TECHNICAL NOTE: Response to Metrolink Queries in relation to Solar Glare from 2-4 Whitworth Street

Following consultation feedback provided by Transport for Greater Manchester on 13th January 2025, regarding potential solar glare impacts of the proposed development on drivers of Metrolink trams, GIA have prepared the following responses and provided additional information where necessary.

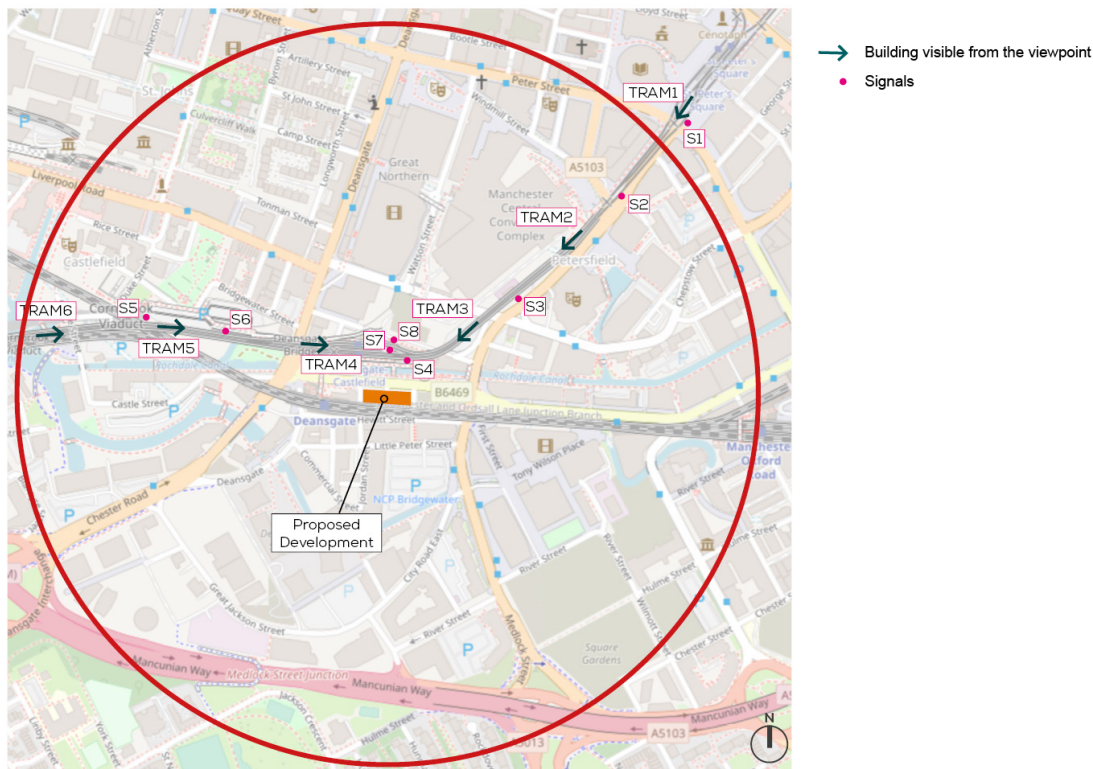
Query 1 - Selection of Viewpoint

GIA confirm that the selection of viewpoints has been informed by the location of signals within the relevant stretch of track. The below map identifies where GIA understand signals to be located and their relationship to the viewpoints assessed within the submitted ES Chapter. The only signal that's approach has not been assessed is Signal 2 however as there is no significant concern for Signals 1 and 3, it is expected that Signal 2 would have similar conditions. Regarding Signals 7 and 8, these are end of platform signals and the proposed development would no longer be visible so they do not require consideration. Therefore, it is not considered that any additional viewpoints require assessment to understand the impact on signal sighting.

For completeness, the relevant signals serving the eastbound trams have been added to the revised imagery provided in Appendix 1 and 2.

APPENDIX 1 - ASSESSMENT OF REVISED VIEWPOINT HEIGHTS

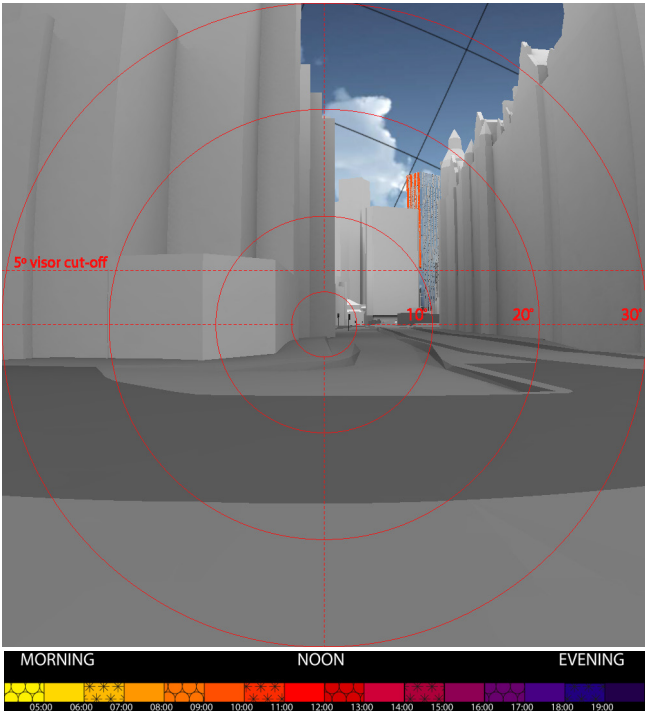
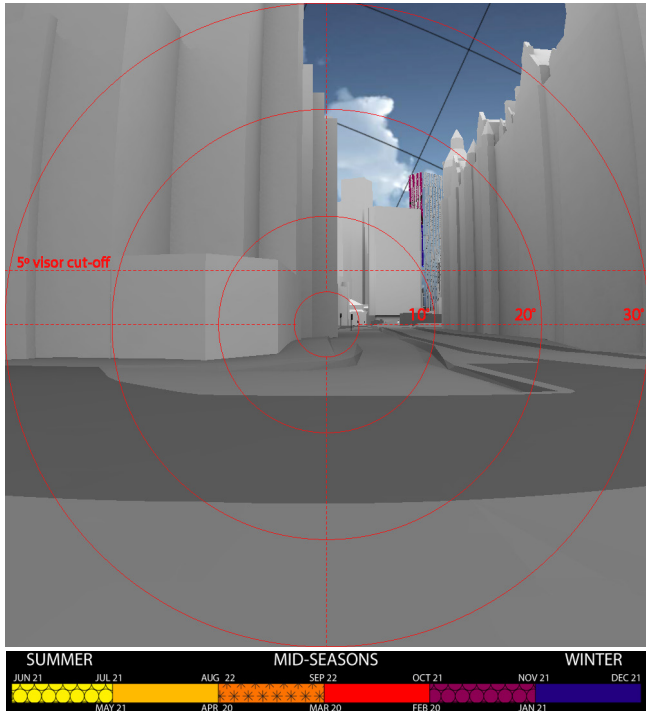
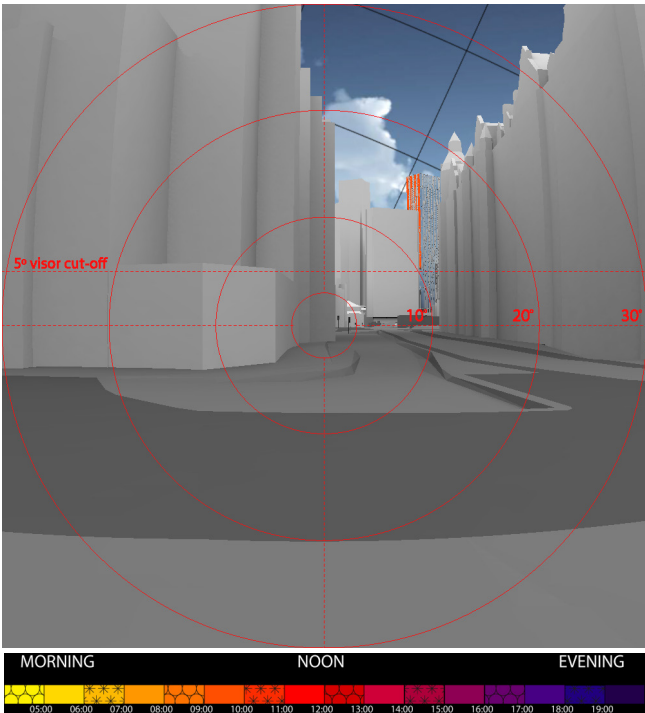
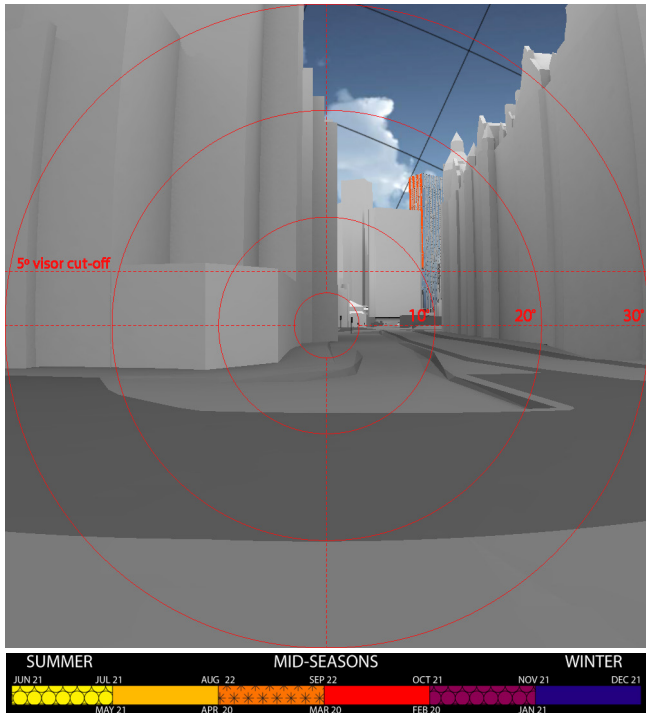
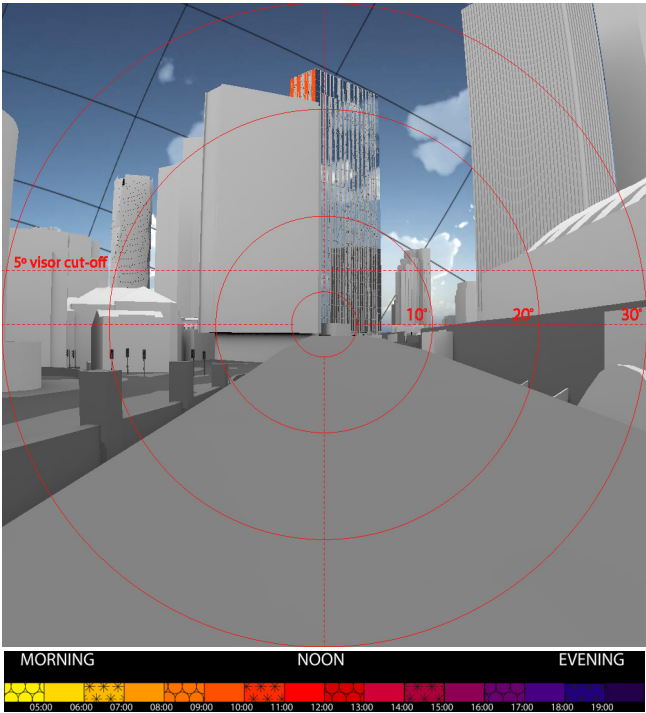
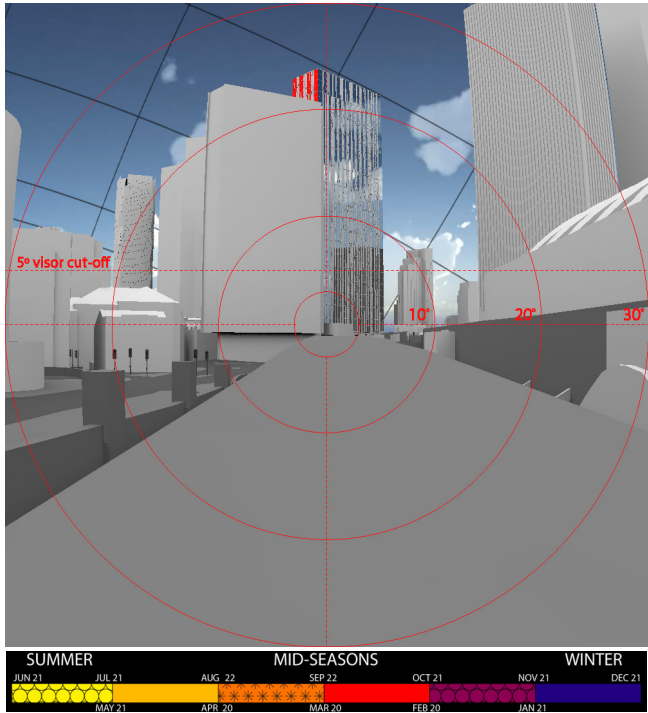
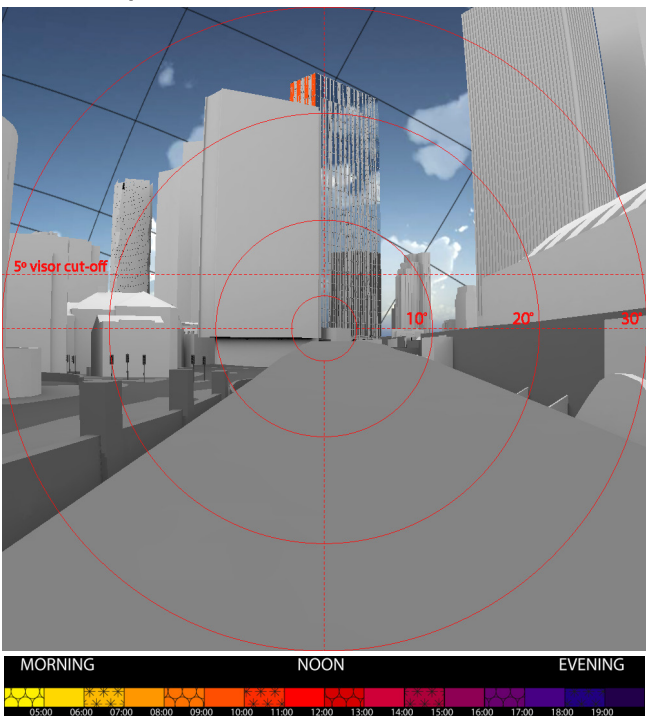
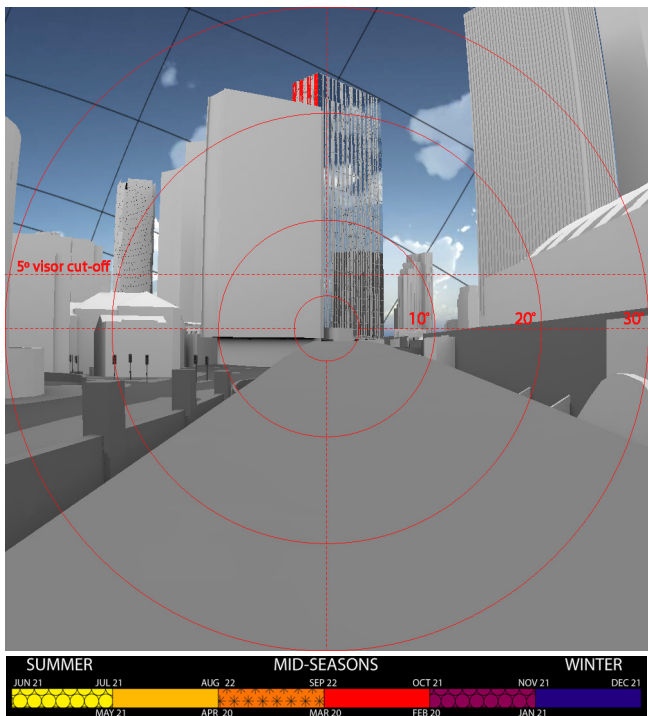
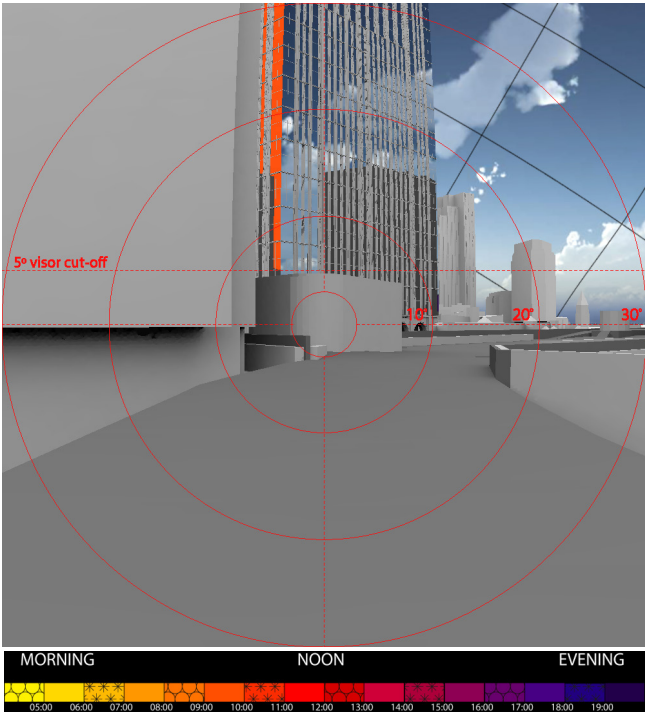
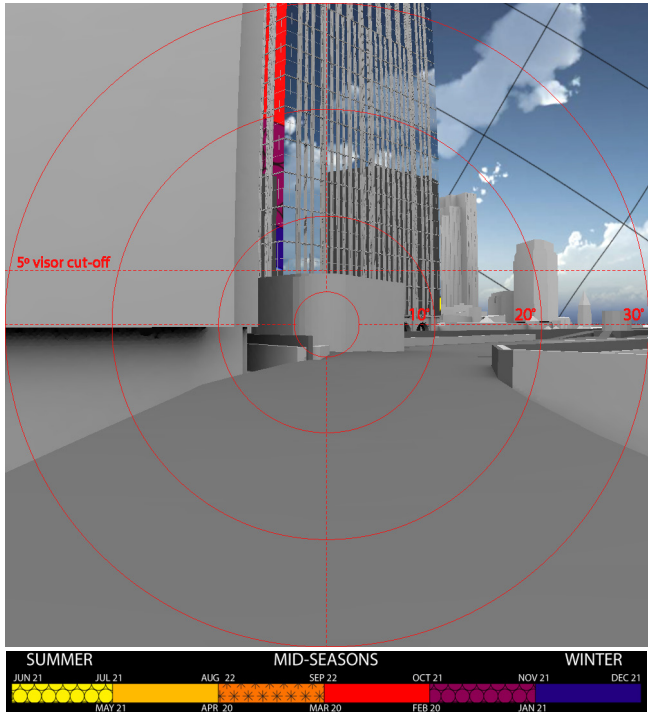
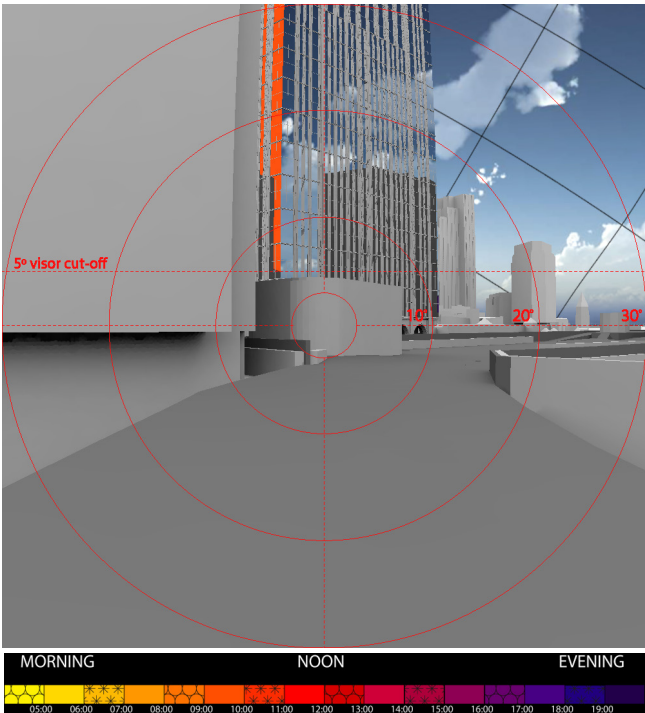
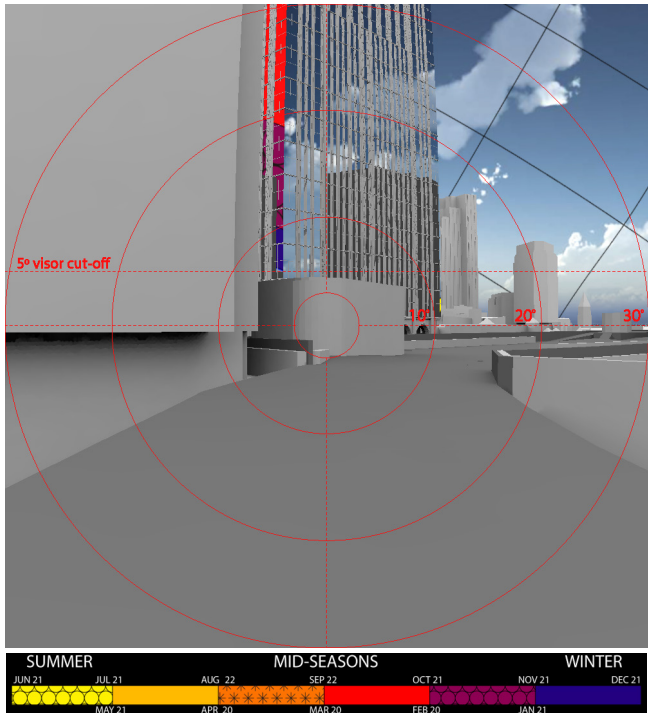
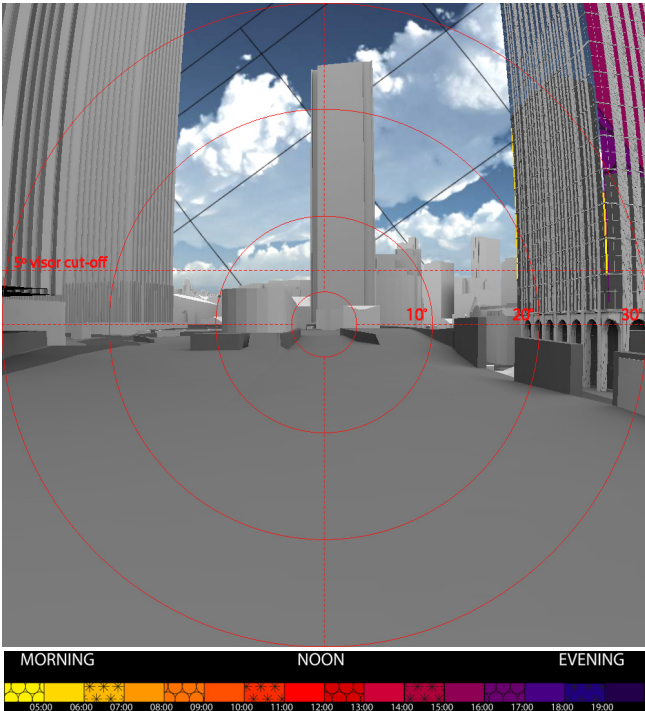
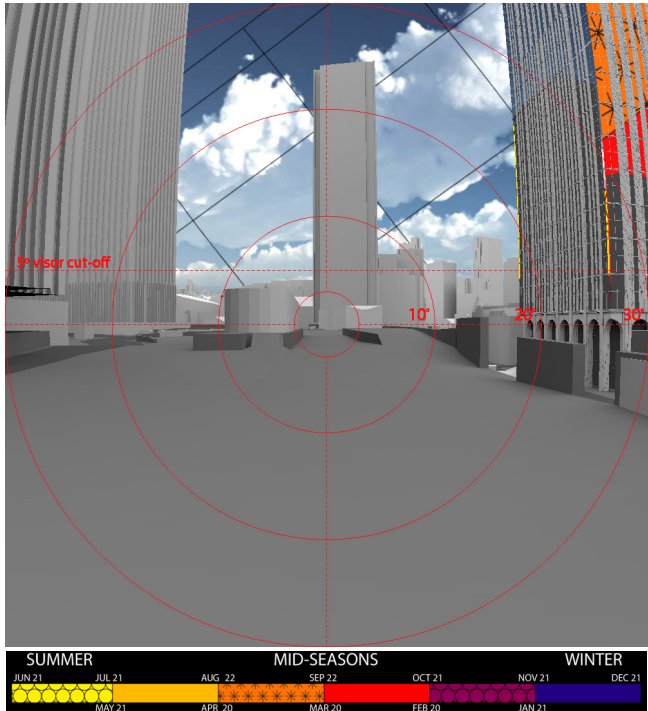
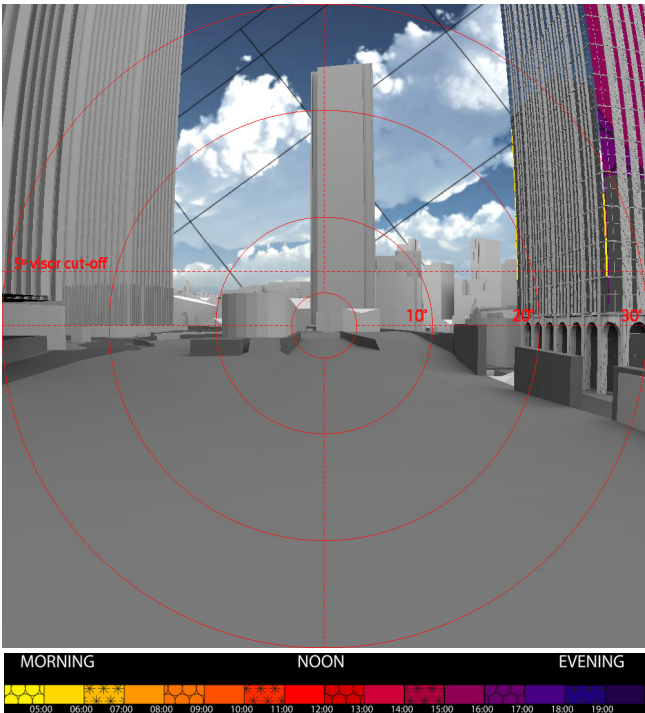
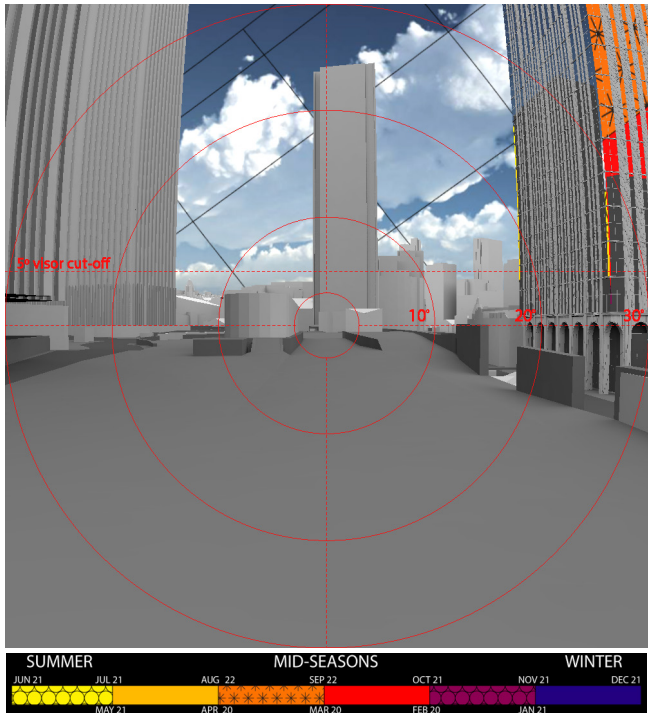
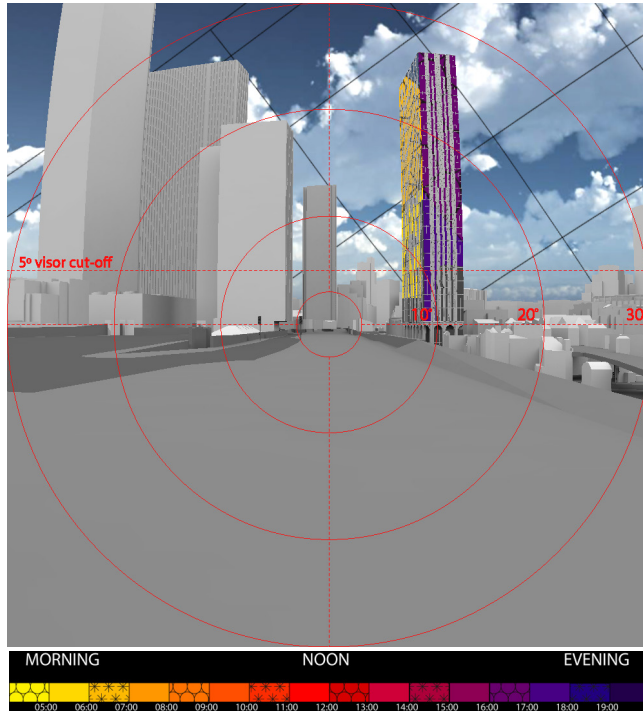
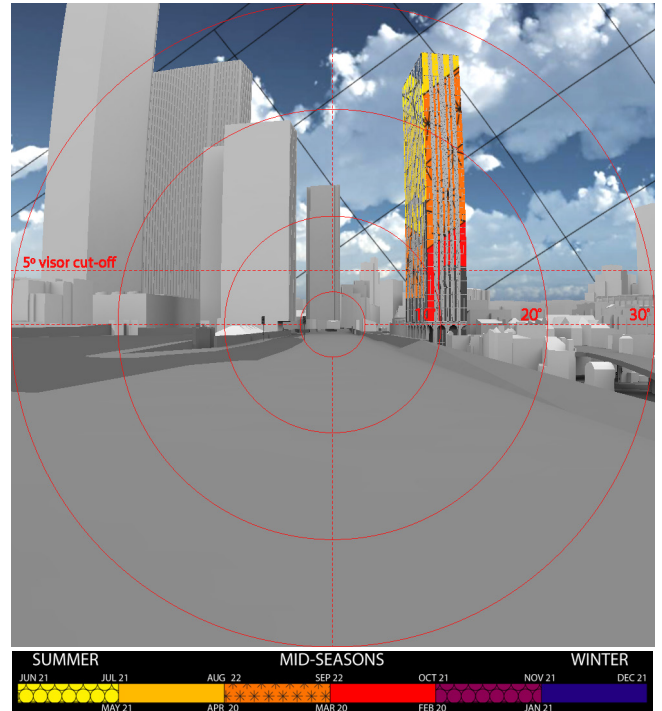
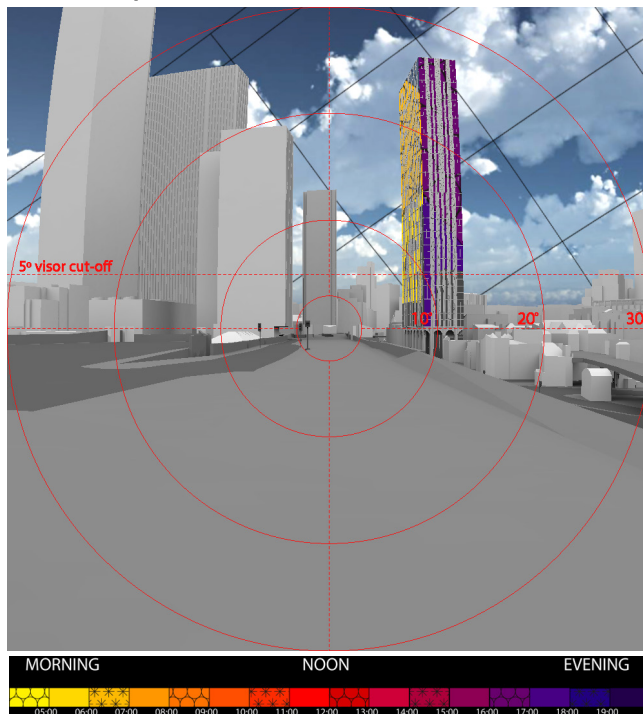
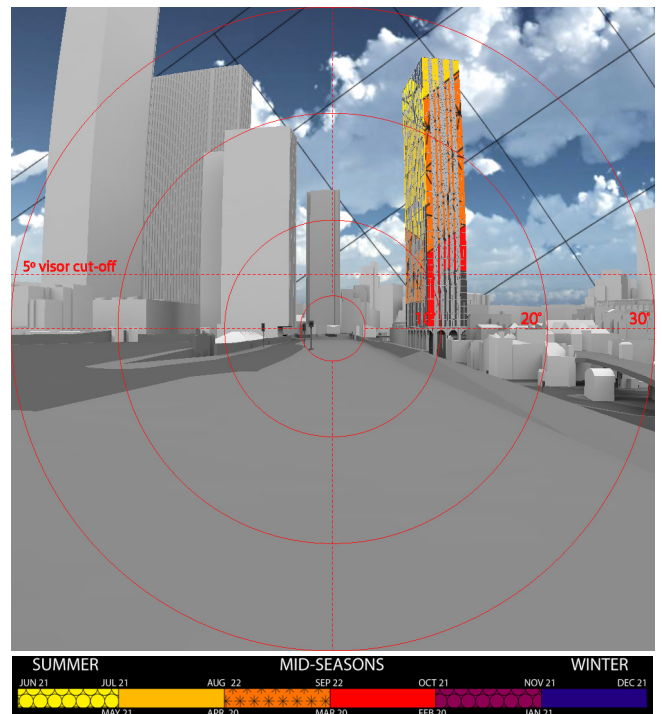
Query 2 - Viewpoint Height

It has been confirmed by TfGM that the viewpoint height is 2.2m not 2m as assessed has been noted. Whilst we do not consider this would alter the effects nor conclusions set out in the ES, for completeness, GIA has update the analysis and provided these results in Appendix 1 alongside those submitted for comparison purposes. The results provided in Appendix 1 confirm there is no noticeable difference between the results of the raised viewpoints at 2.2m compared to the 2m high viewpoints as submitted, therefore the effects and conclusions set out within Chapter 12 of the ES remain unchanged.
